ISSUE: Certificate of Appropriateness for alterations

APPLICANT: Donald D. Devers

LOCATION: Parker-Gray District
1213 Queen Street

STAFF RECOMMENDATION

2
A-1
PROPOSED SOUTH ELEVATION
SCALE: 1/8" = 1'-0"

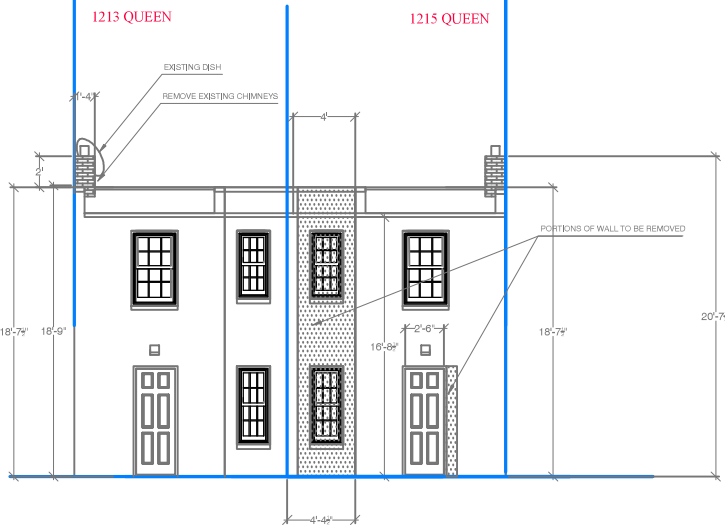
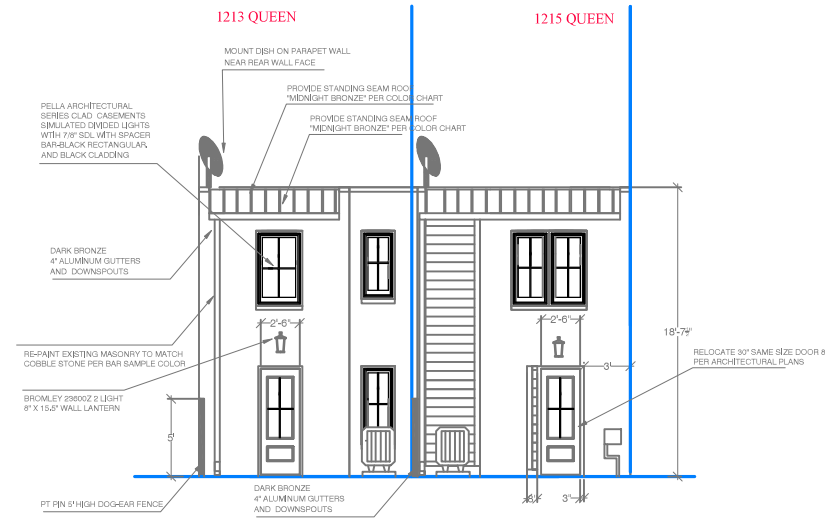
1. The proposed triangular pediment be removed or the applicant work with staff to find an architecturally appropriate rectangular pediment; and,
2. The existing chimney be retained and repaired as needed.

The applicant also proposes to replace the existing six-panel doors and to add a triangular door pediment over the existing door surround on the south elevation. Staff objects to the door hood on the façade because these architectural features are not compatible with the existing features on the property. The door on the south elevation will be a four-panel wood door. Staff has no objection to the proposed door on the north elevation, as it will be minimally visible from the public alley and does not require Board review, as stated in the Parker-Gary Residential Reference Guide.

PROPOSED SOUTH ELEVATION
SCALE: 1/4" = 1'-0"

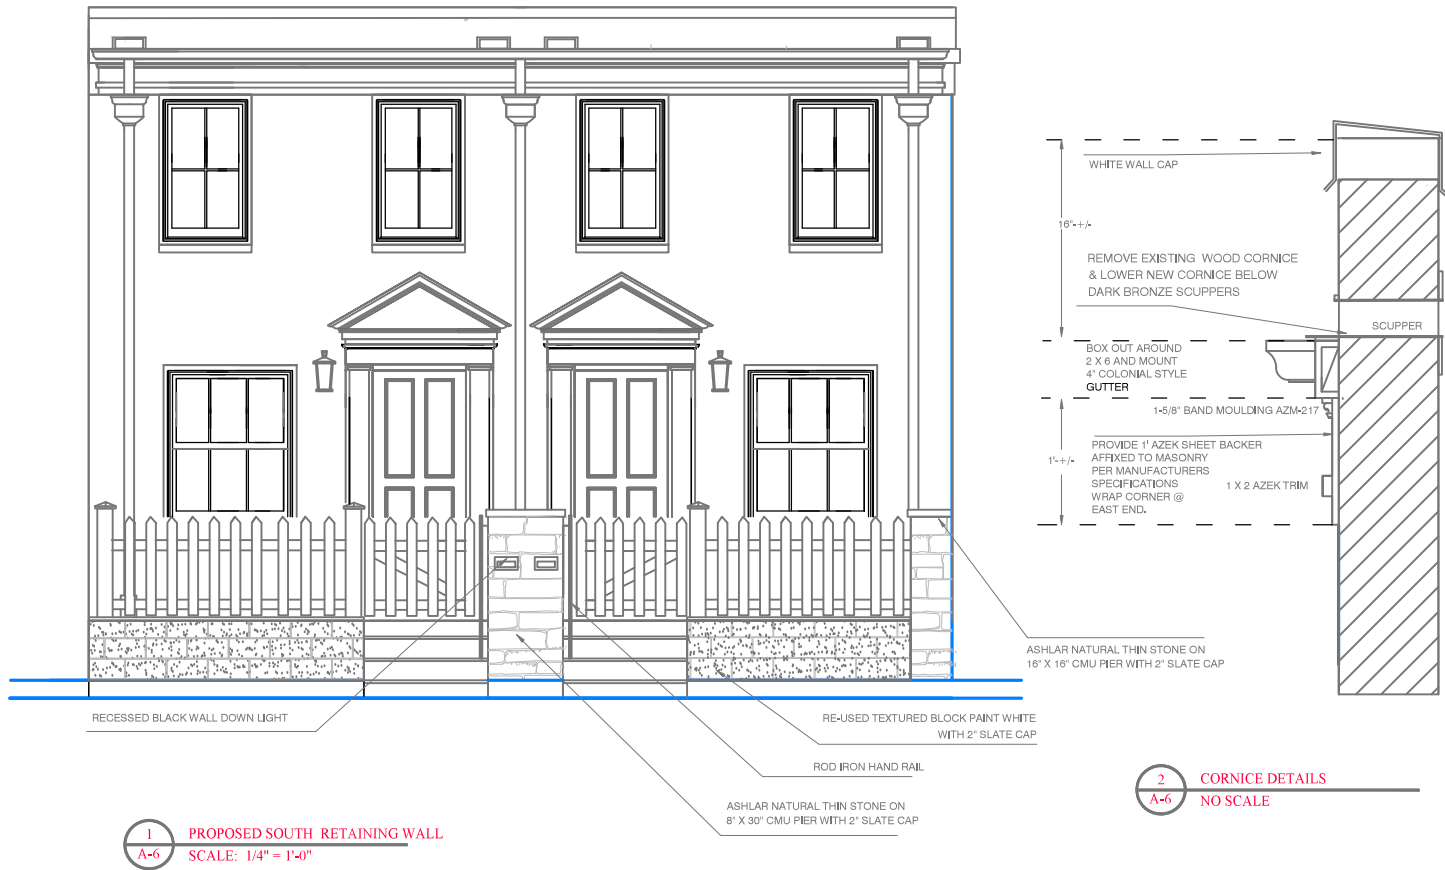
Additionally, the applicant is proposing to demolish the existing chimney. The *Design Guidelines* state that "chimneys are important functional elements of a building and provide visual variety to the roofline." Staff recommends that the existing chimney be retained and repaired as needed because it has an important impact on the roofline and overall visual composition of the building.
